**STATE OF TENNESSEE
DEPARTMENT OF TRANSPORTATION**

INSTRUCTIONAL BULLETIN NO. 17-05

Regarding Revised Standard Drawings

Effective June 23, 2017 letting (April 5, 2017 Turn-in), the following Standard Drawings have either been revised to incorporate the new MASH Items Numbers. Also, Chapter 5 of the Roadway Design Guidelines has been revised to incorporate these changes.

TYPE 38
GUARDRAIL END
TERMINAL

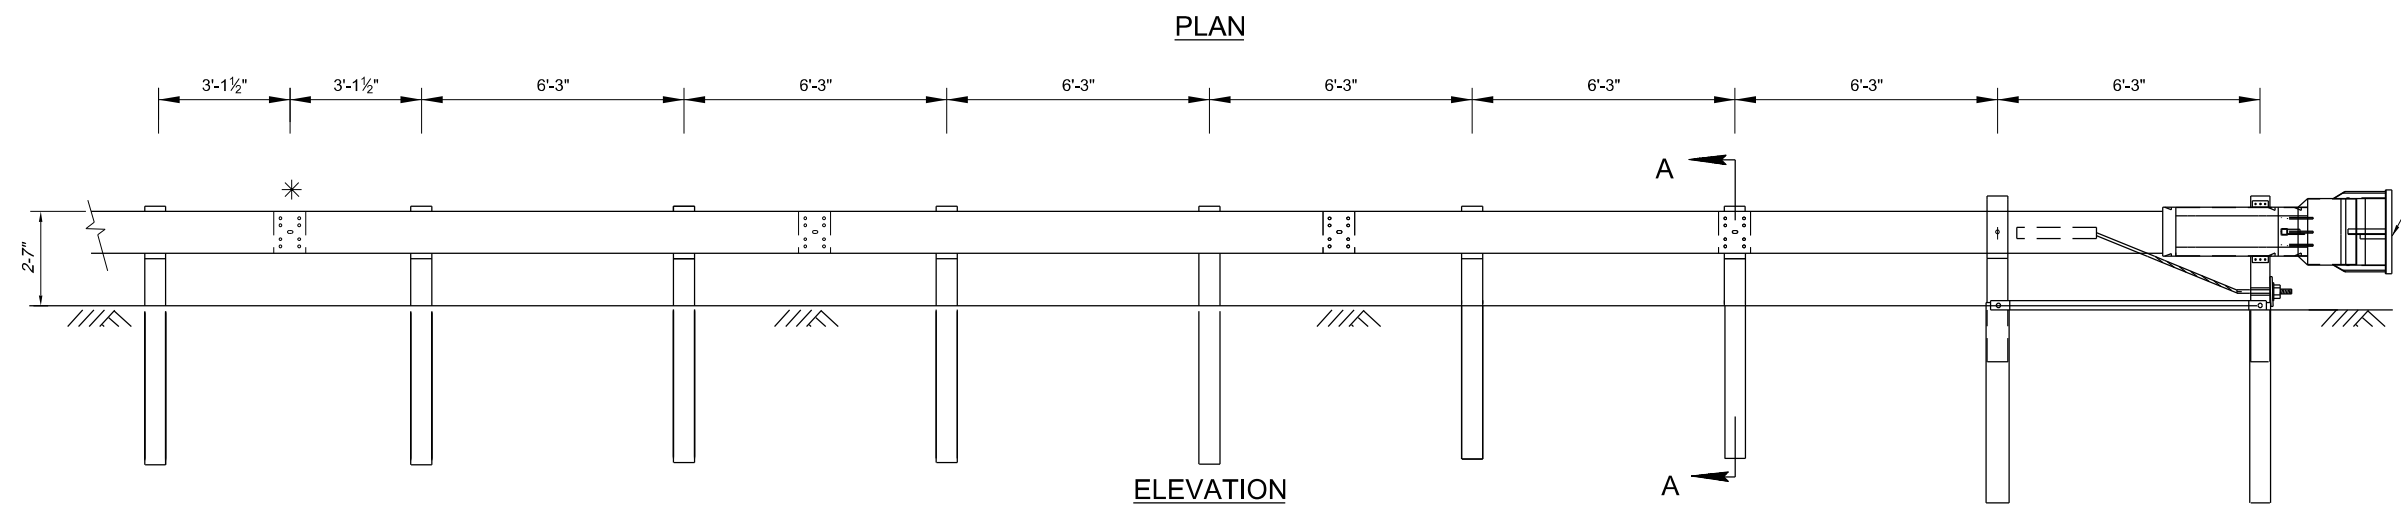
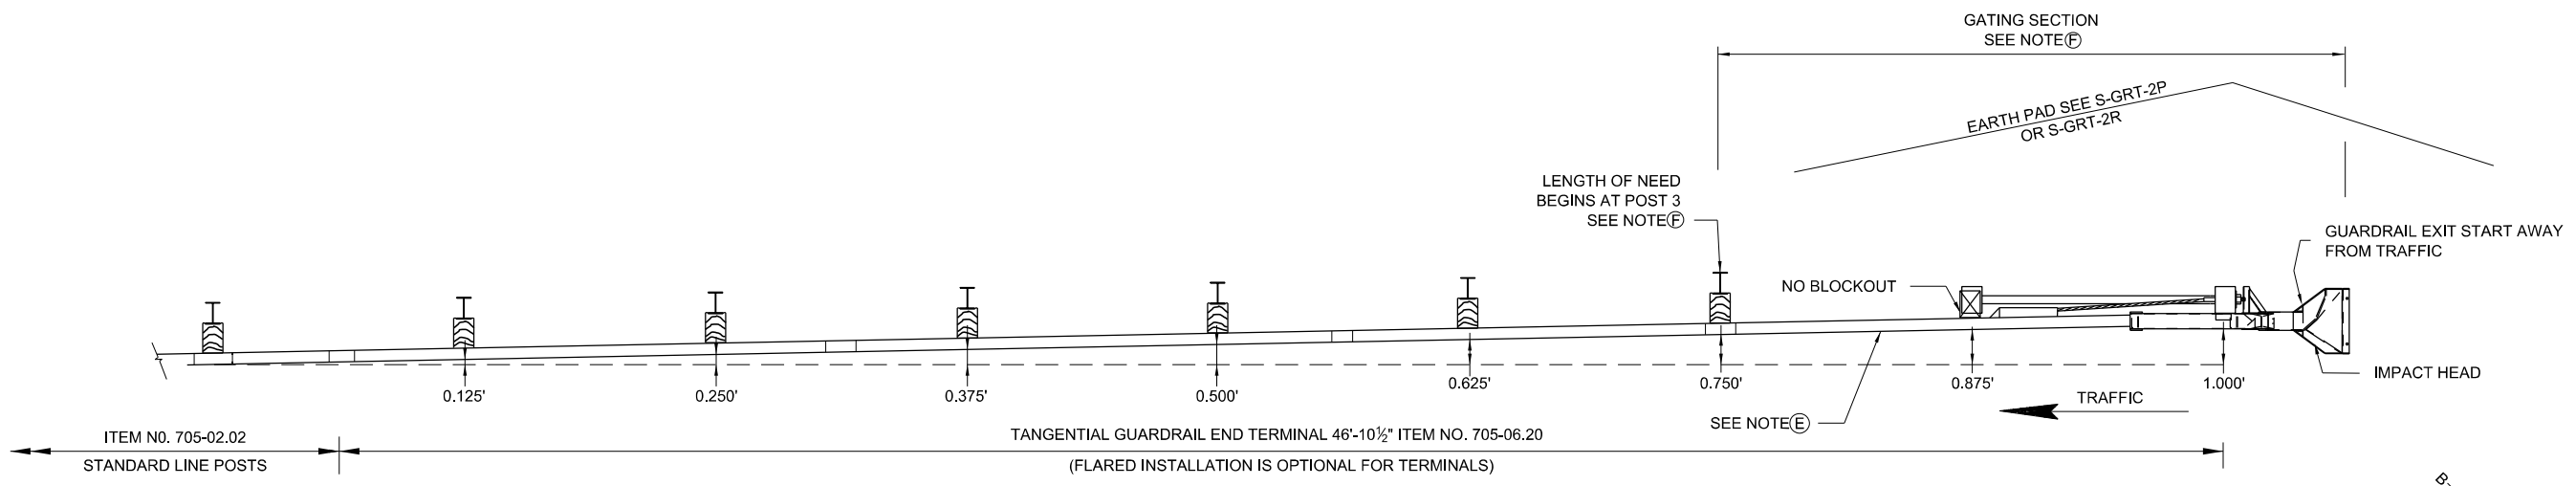
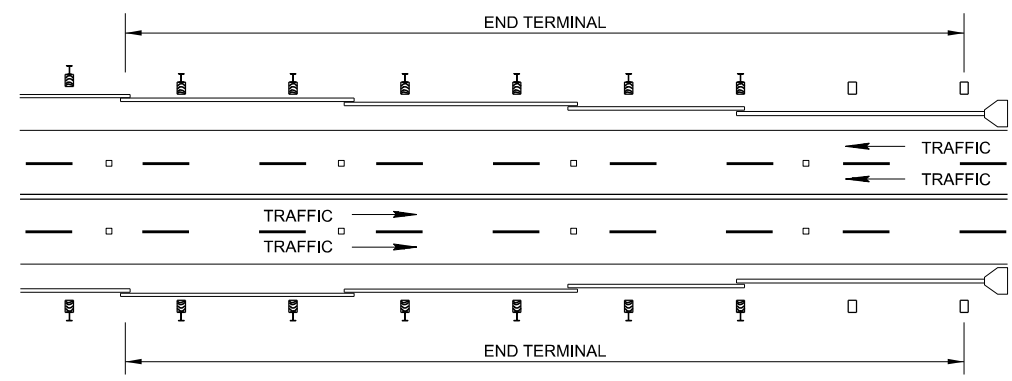
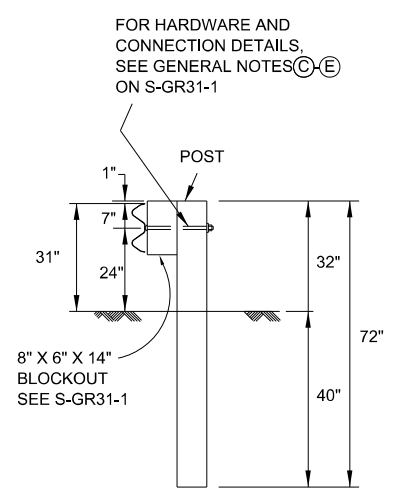
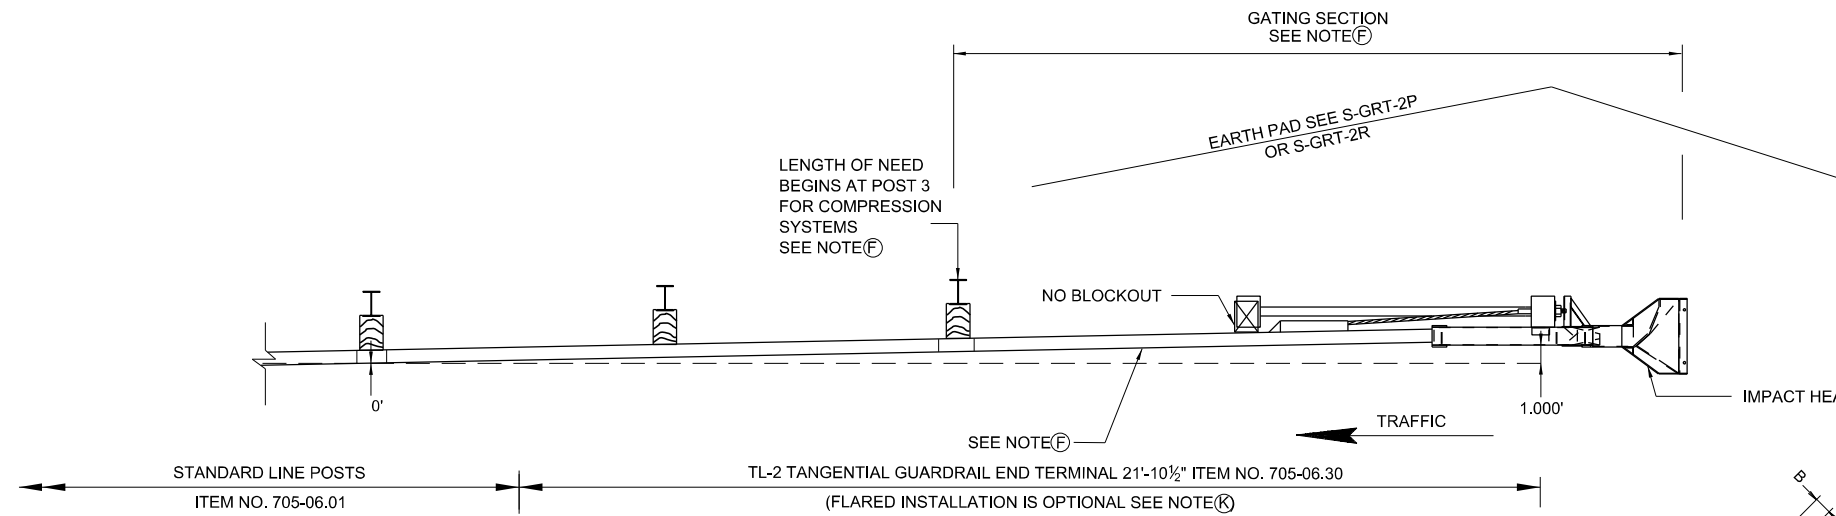
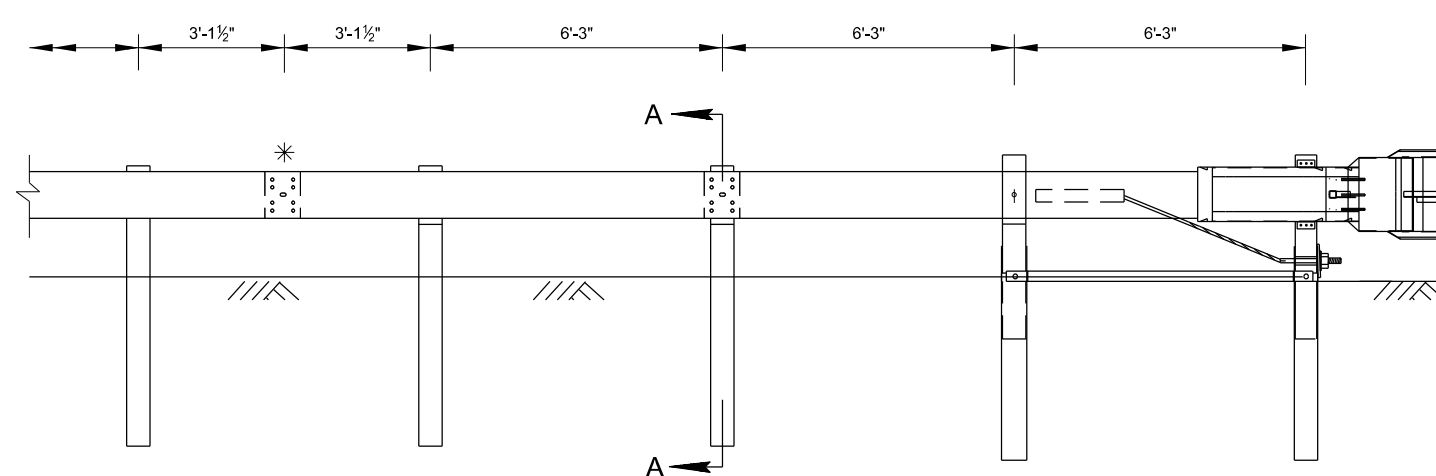
REV. 3-28-17: UPDATED NOTES TO INSTALLER. ADDED W-BEAM OVERLAPPING DETAIL REORGANIZED SHEET. CHANGED PAY ITEM NUMBER. REPLACED "SKT350" WITH "SKT-SP-MGS" IN NOTE TO INSTALLER.

TYPE 21
GUARDRAIL END
TERMINAL

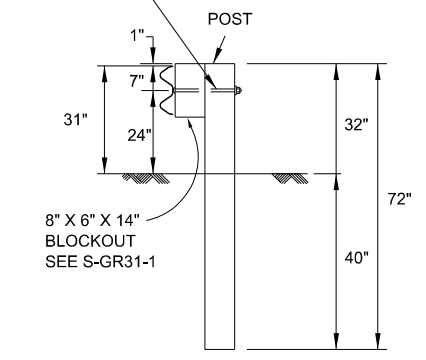
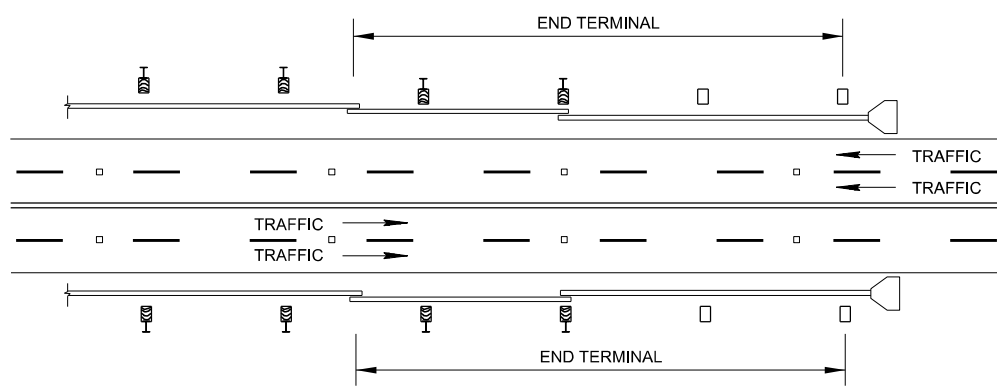
- REV. 11-3-14: MODIFIED PAY LENGTH FOR TYPE 38 END TERMINAL.
- REV. 4-4-16: THE PREVIOUSLY SHOWN SKT75 (SLOTTED FLARED GUARDRAIL TERMINAL) IS NO LONGER AVAILABLE FOR 31" INSTALLATION. REVISED TO SHOW TL-2 T-350 TERMINAL.
- REV. 10-10-16: UPDATED LIMIT OF PAYMENT.
- REV. 3-28-17: UPDATED NOTES TO INSTALLER, ADDED W-BEAM OVERLAPPING DETAIL, REORGANIZED SHEET, CHANGED PAY ITEM NUMBER, REPLACED "SKT 350" WITH "SKT-SP-M65" IN NOTE TO INSTALLER.
